JOINT REGIONAL PLANNING PANEL (Sydney East Region)

JRPP NUMBER:	2011SYE124
DA NUMBER:	LDA2011/0622
LOCAL GOVERNMENT AREA:	City of Ryde
PROPOSED DEVELOPMENT:	Construction of an eight storey mixed use development containing retail/commercial floor space at the Ground Floor level; 68 residential apartments; and parking for 119 motor vehicles over three and a half basement levels.
STREET ADDRESS:	1-3 Wharf Road Gladesville
APPLICANT:	Windesea Build Pty Ltd
NUMBER OF SUBMISSIONS:	58 objection letters and 419 letters of support.
RECOMMENDATION	Refusal
REPORT BY:	Architectus Group Pty Ltd, Consultant Town Planners to City of Ryde Council

Assessment Report and Recommendation

Figure 10 Area of non-compliance with the maximum 22 metre LEP Height Standard (North Elevation)

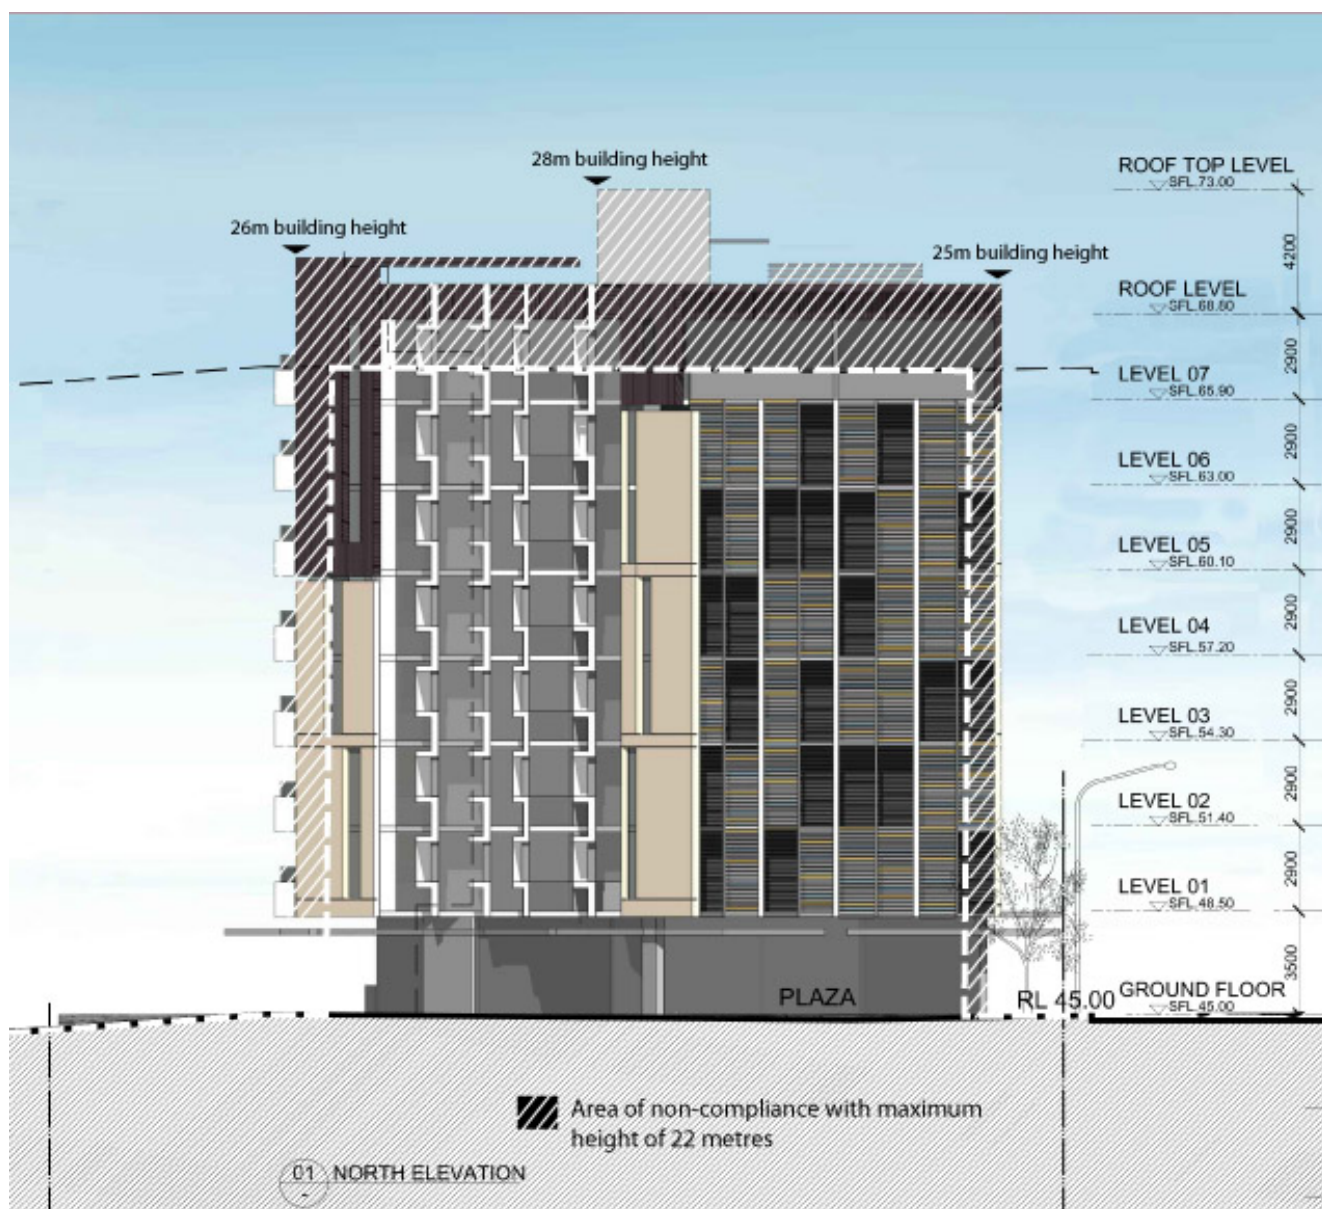
The proposed development exceeds the maximum LEP height standard of 22 metres by up to 8 metres within the subject site. The development also extends beyond the site boundary. Under the Ryde LEP 2010, no development is permitted within this area of the site. The extent of the proposed non-compliance with the LEP height standard is illustrated at **Figure 10** and **Figure 11**.

- The proposal will result in a development which significantly exceeds the bulk and character of development envisaged for the Gladesville Town Centre under the Ryde LEP 2010 and Ryde DCP 2010, prepared following extensive community consultation and urban design analysis. The controls envisage development in the town centre generally between 2 to 6 storeys, with limited opportunity on other sites up to 8 storeys.

- The proposal encroaches the current boundaries of the site into the Wharf Road and Meriton Road reservations. No height is permitted in these areas under the Ryde LEP 2010.

Figure 12 Site portions for calculating FSR

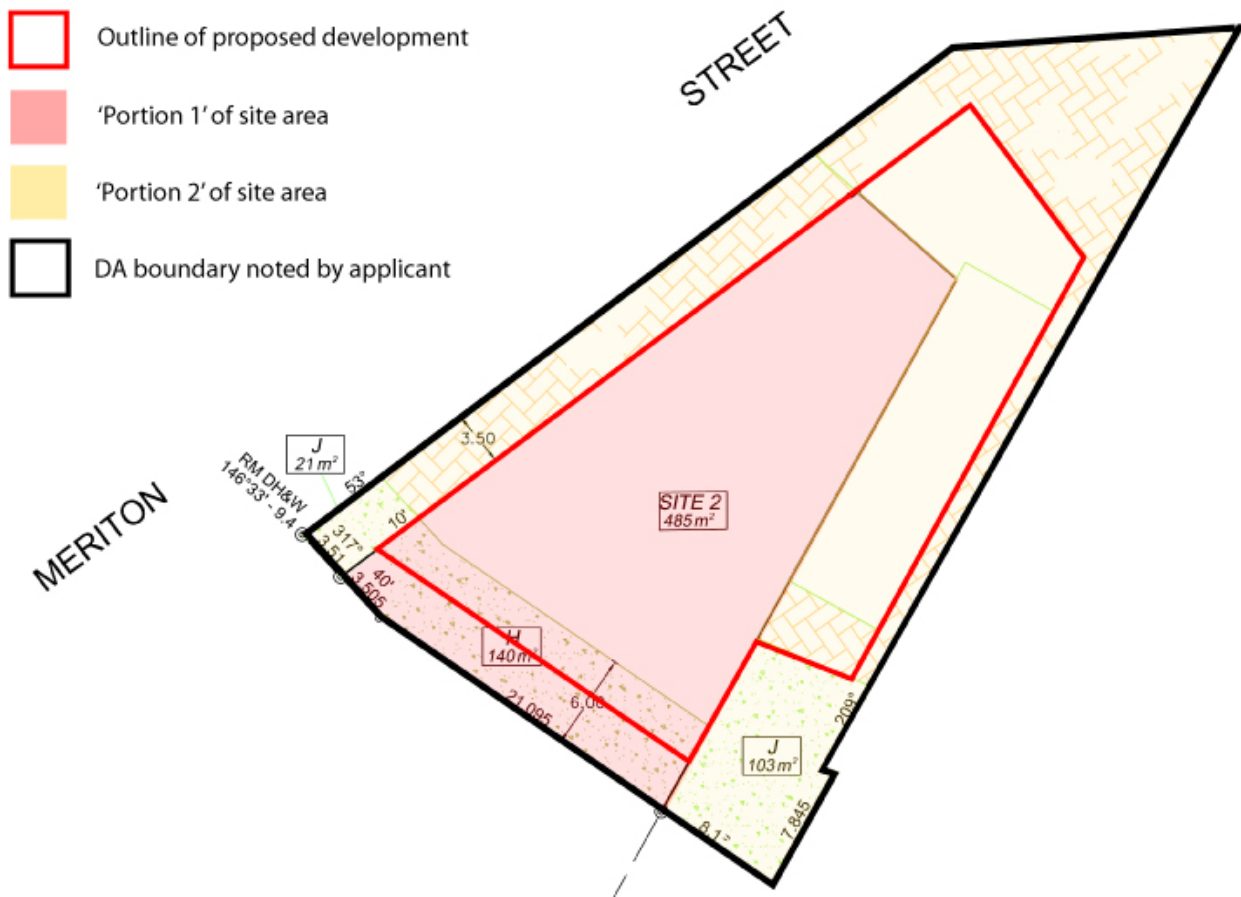
The FSR of the two portions of the site are outlined under **Table 1** below. The two portions of the site for the purposes of determining site area and calculating the FSR are illustrated at **Figure 12**.

As outlined above, the proposed development provides a significant variation to the maximum FSR for the subject site, and proposes further gross floor area beyond the site boundary in areas which zero floor space is permitted under the LEP. Under the LEP, zero floor space is shown within the Wharf Road reservation.

The Applicant has provided justification for a lesser non-compliance of 0.39:1, rather than the actual non-compliance of 2.48:1 as well as an additional 1,922m² of gross floor area located outside the current site boundaries. It is therefore considered that the proposed FSR, which provides a significant departure from the maximum FSR of 3.5:1 (70.8% plus additional floor space outside of current site boundaries), is unacceptable under the current planning controls.

Figure 14 Proposed Key Sites built form plan

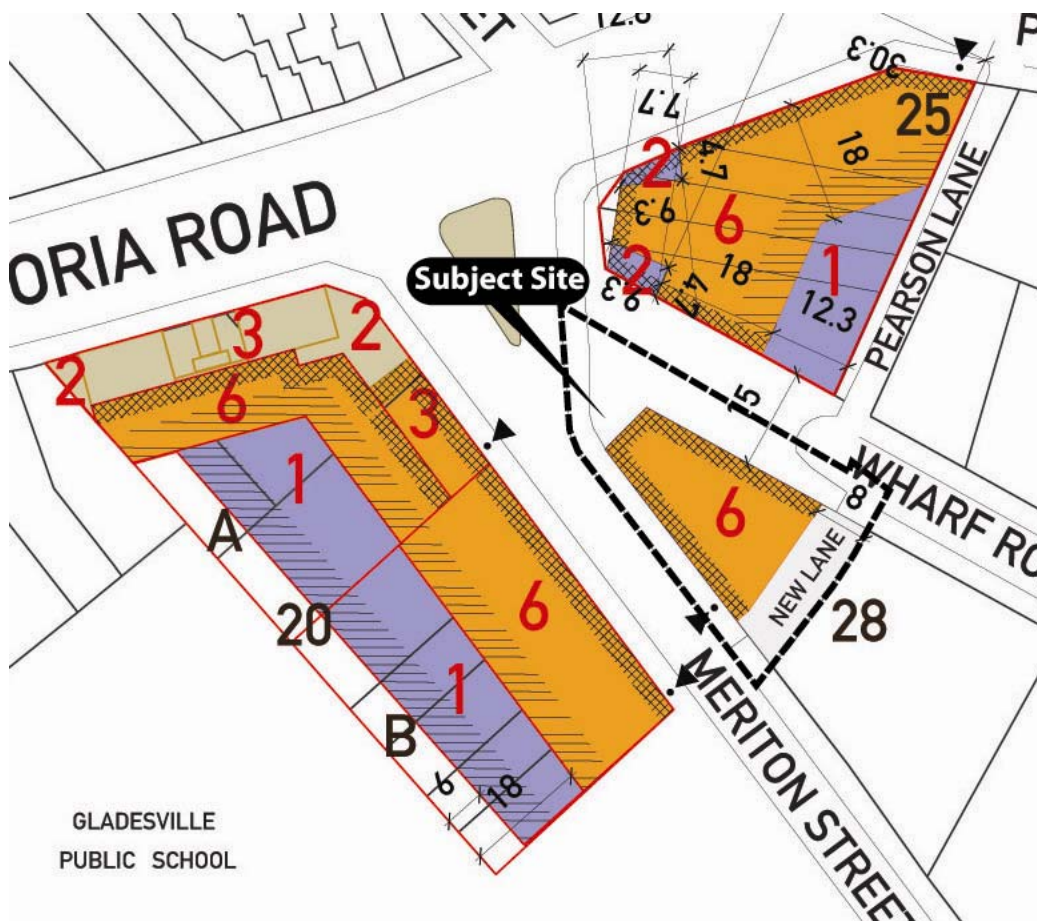
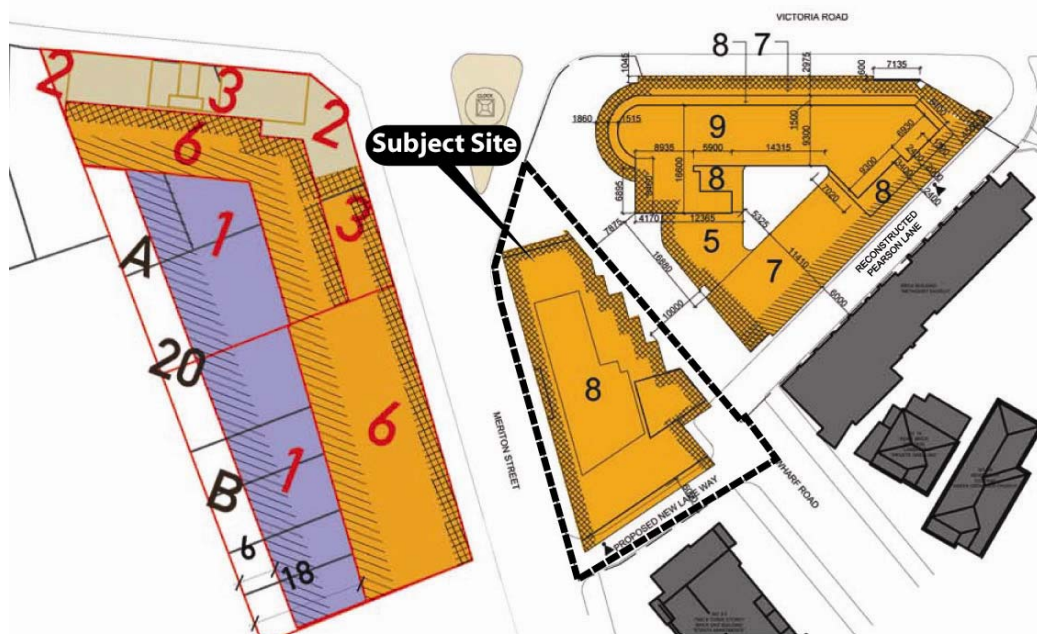
The proposed development is inconsistent with the key sites diagram for the subject site. The Applicant has submitted an alternative Key Sites diagram. The DCP (**Figure 13**) and proposed (**Figure 14**) Key Sites diagrams are illustrated below. In summary, the Applicant's proposed alternative Key Sites diagram increases building height to 8 storeys plus plant, and increases site coverage and building footprint.

It is considered the proposal does not meet the criteria for variation of the Key Sites Diagram, provided by Section 4 of Part 4.6 of Ryde LEP 2010, given the following:

Figure 15 Non-compliance with the maximum Key Sites diagram envelope

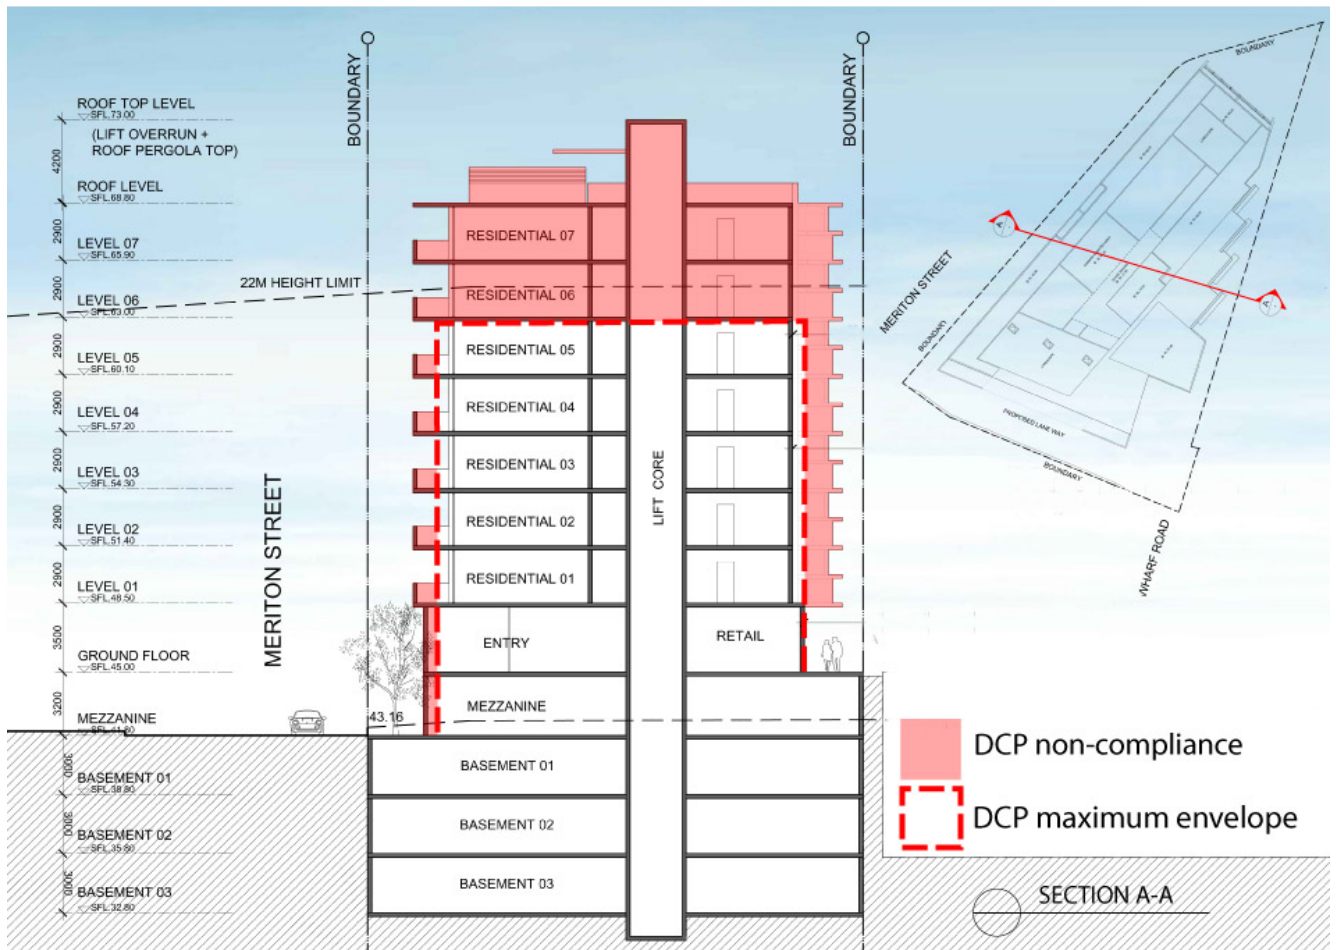
The maximum height under the adopted Key Sites diagram (or Built Form Plan) is 6 storeys across the site with an 8 metre laneway across the southern boundary, which also provides a buffer between the envisaged development and lower density residential development to the south. The non-compliance to the maximum building envelope prescribed under the Key Sites diagram is illustrated at **Figure 15** below. The area of the building outside of the current site boundaries is also illustrated at **Figure 12** under **Note 2** of the Ryde LEP 2010.
